# A d d e n d u m

Iowa Department of Transportation  
Office of Contracts

Date of Letting: March 17, 2015  
Date of Addendum: February 27, 2015

<b>B.O.</b>	<b>Proposal ID</b>	<b>Proposal Work Type</b>	<b>County</b>	<b>Project Number</b>	<b>Addendum</b>
353	78-0801-452	ITS EQUIPMENT	POTTAWATTAMIE	IMN-080-1(452)1--0E-78	17MAR353.A01

ITS PLAN

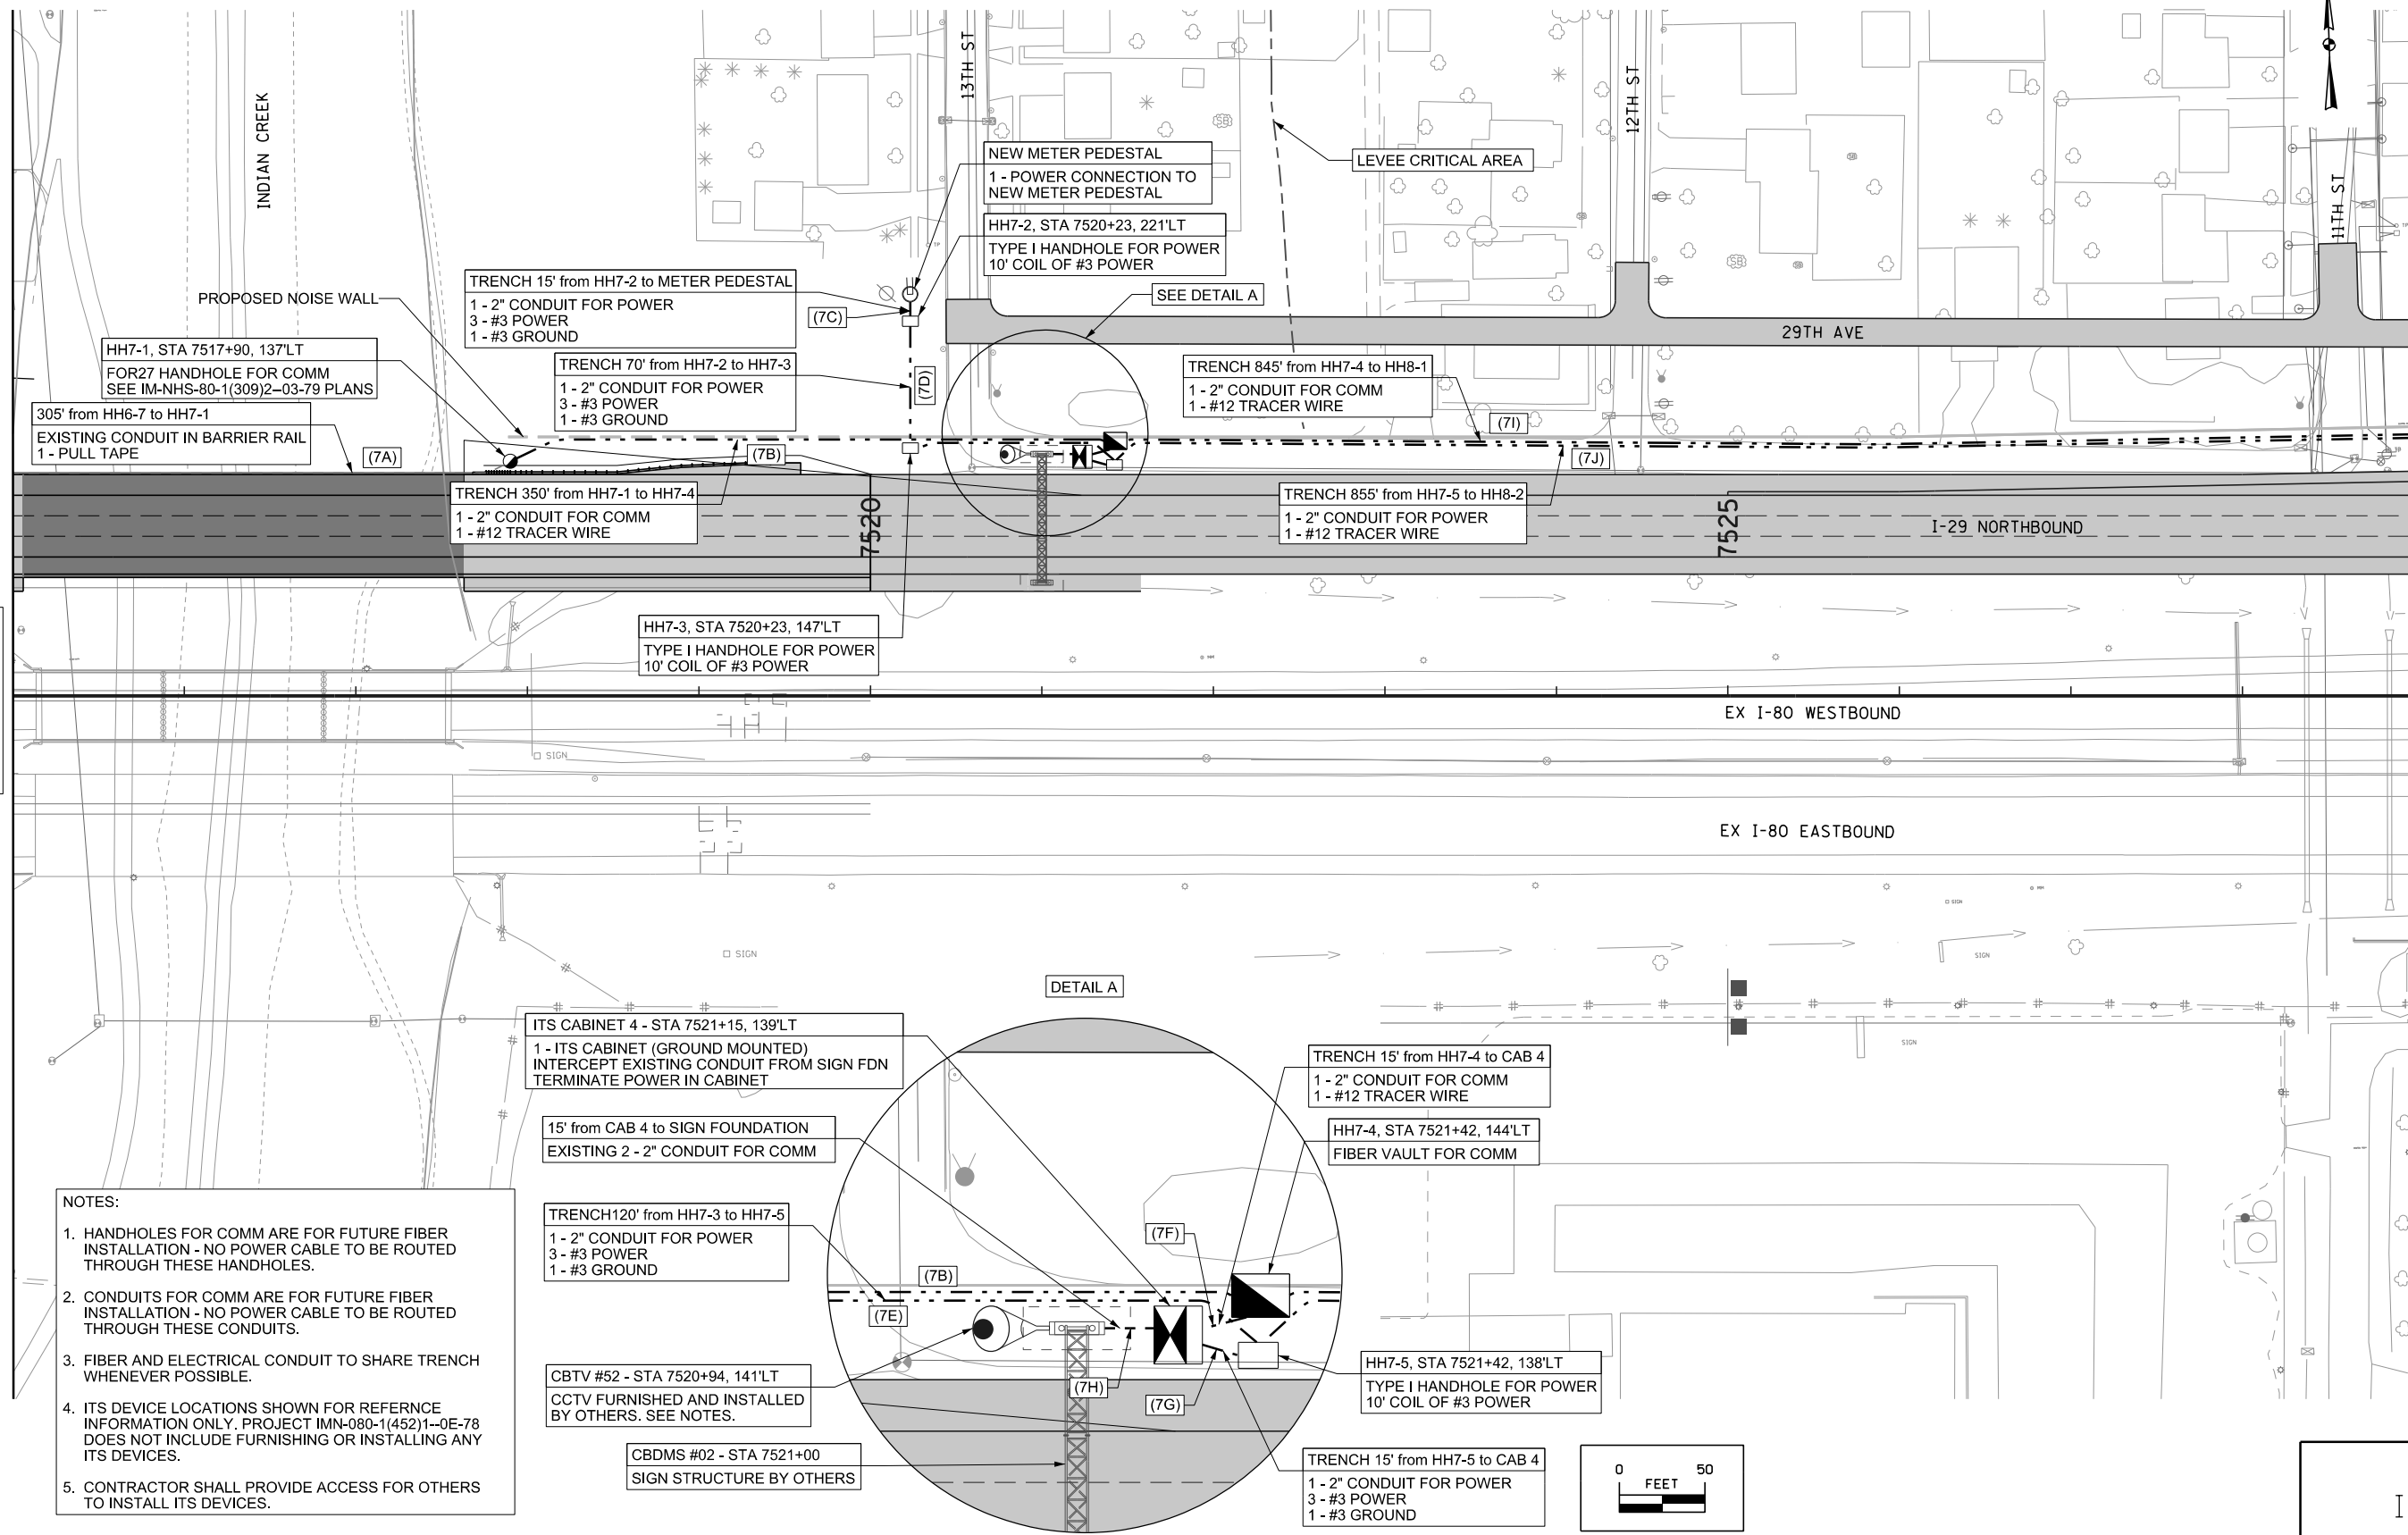
- Replace Sheet N.6 with attached sheet N.6
  - Based on electrical discussion, power needs include 3-#2 Power and 1-#2 Ground (see conduit runs 6A, 6B & 5I)

- To account for future power cables, an additional conduit has been added to conduit runs 6A & 6B
- Replace Sheet N.7 with attached N.7
  - Based on electrical discussion, power needs include 3-#2 Power and 1-#2 Ground (see conduit runs 7C, 7D, 7E & 7G)

U.3-1 - CABINET FRONT VIEW  
NOT TO SCALE

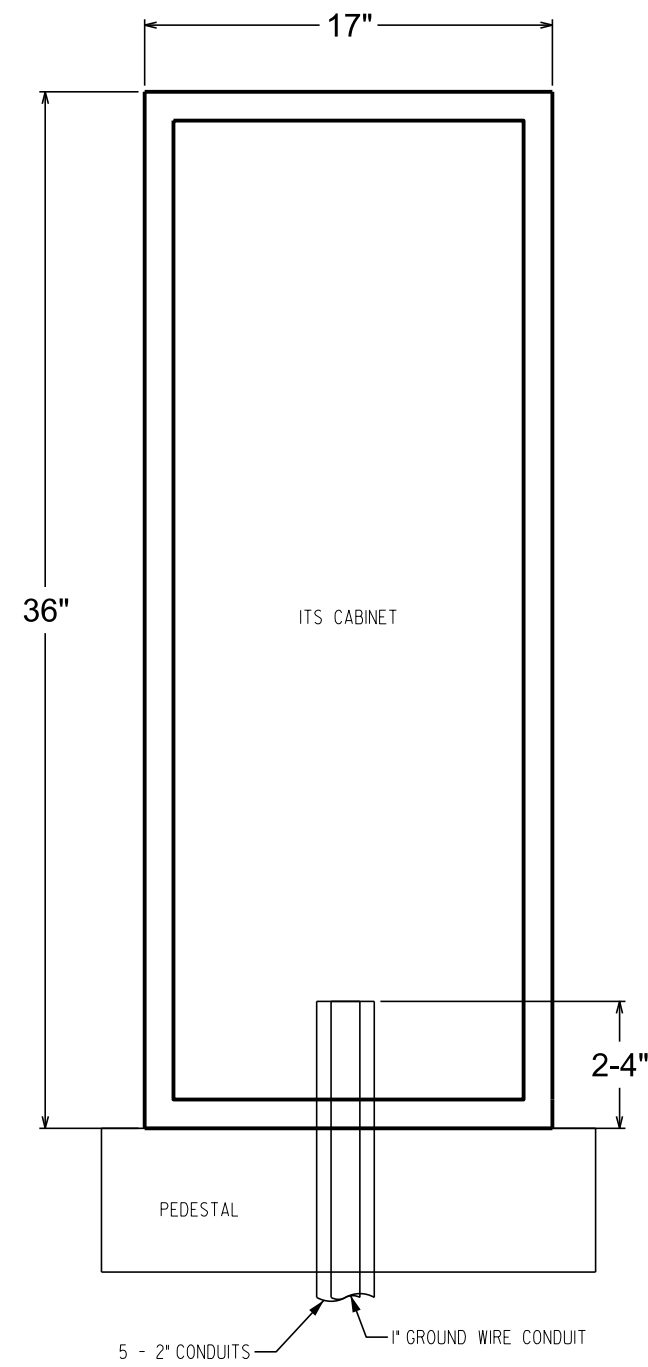
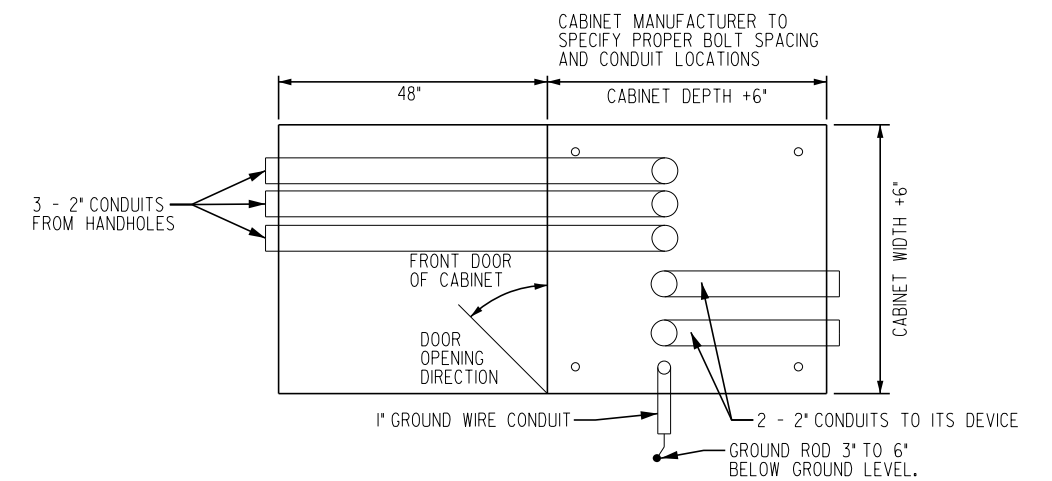
- Replace Sheet U.3 with attached U.3
  - Step down transformer removed from Figure U.3-1 and Figure U.3-2
- Replace Sheet U.4 with attached sheet U.4
  - Cabinet Layout modified based on discussion to accommodate 120/240V operations.
